**CITY OF HUTTO, TEXAS
ZONING BOARD OF ADJUSTMENT
REGULAR MEETING
OCTOBER 24, 2018 AT 7:00 PM
BUSINESS & DEVELOPMENT SERVICES OFFICE
210 US 79 EAST #103**

Consideration of a public hearing and possible action on variance request #1.42 for the property located at 210 Ed Schmidt Boulevard from the Commercial, Office, Public, Institutional, and Mixed Use Building Design requirements, as outlined in Section 10.406 of the Unified Development Code (UDC) ,

Re: Hanson's Corner Shopping Center - Hutto, TX
Variance Request Application - Letter of Nature of Request – Revised – R2

FROM: Ashby Grundman, Director of Planning
TO: Zoning Board of Adjustment
SUBJECT: Item #1.42- 210 Ed Schmidt Boulevard – Commercial Building Design

⑤ East Elevation
1/8" = 1'-0"

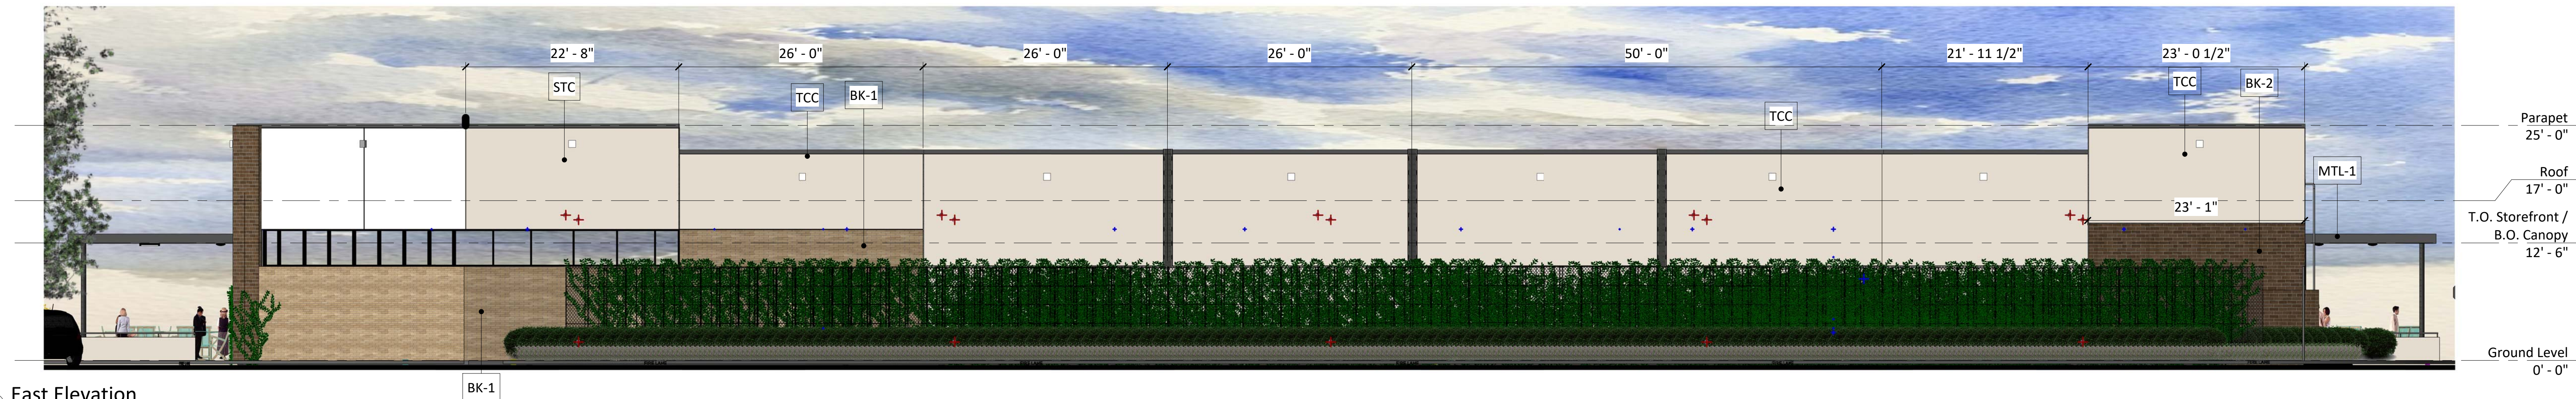
Chapter 4, Section 10.406.6.7.1: Variance requested at East (Back of Building). This façade is mathematically short of 50% masonry requirement. A large portion of it is screened by a green screen and should not be visible to the public from major drive aisles at driver/pedestrian level. The remaining façade as viewed from the adjacent streets will appear to meet the masonry requirement, refer to attached views.

Chapter 4, Section 10.406.4.4: Variance requested at East (Back of Building). 102’ of façade in the middle of this elevation is interrupted by vertical metal accent brackets, but does not include a second articulation. Again we request that the green screen located in front of this wall be considered as a change in plane and texture, since that is how this side of the building will be viewed from the pedestrian/vehicular level.

5 East Elevation
1/8" = 1'-0"

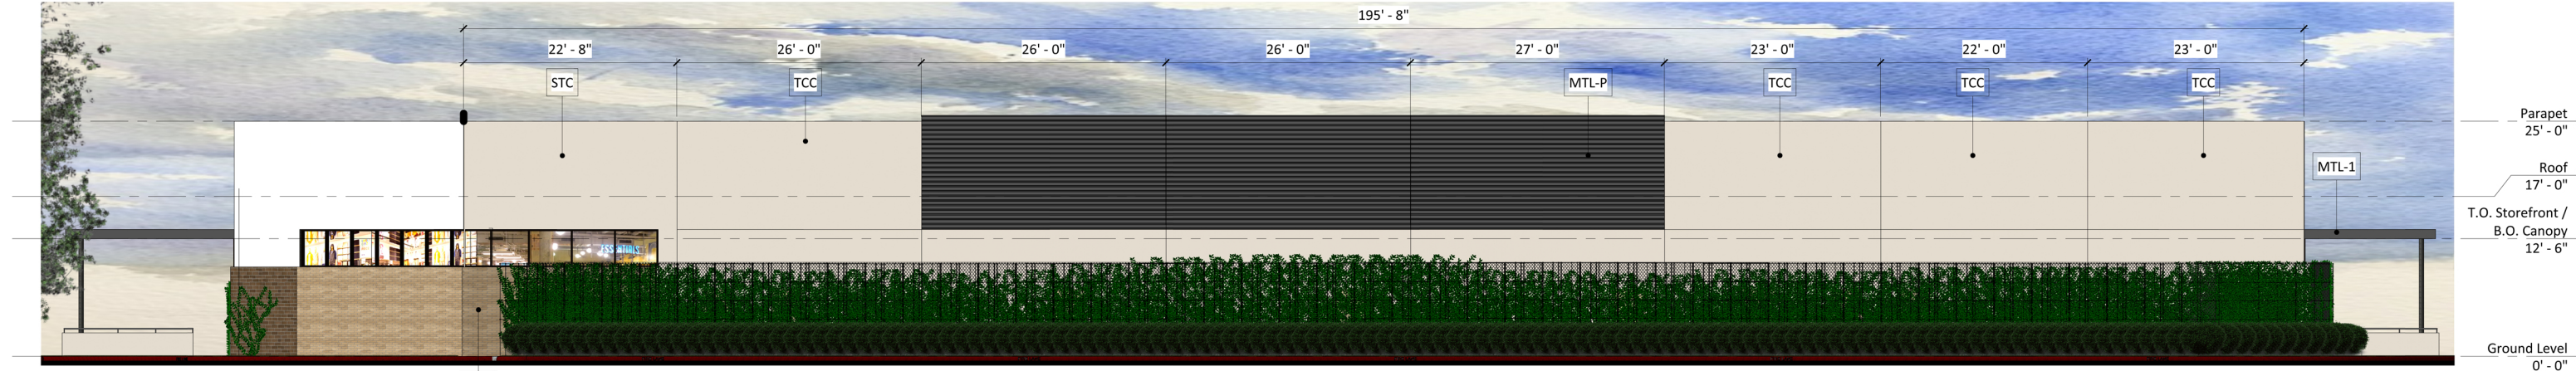
Staff finds that the requested variance is design driven and does not constitute an undue hardship. It is important to note that the masonry percentage required for the rear of the building would be blocked by the green screen, so it wouldn't be visible.

Staff finds that the requested commercial building design variances do not meet the intent of the UDC. However, staff finds that approval of the variance would not adversely impact the neighboring property owners, as the masonry would not be able to be seen by the general public.
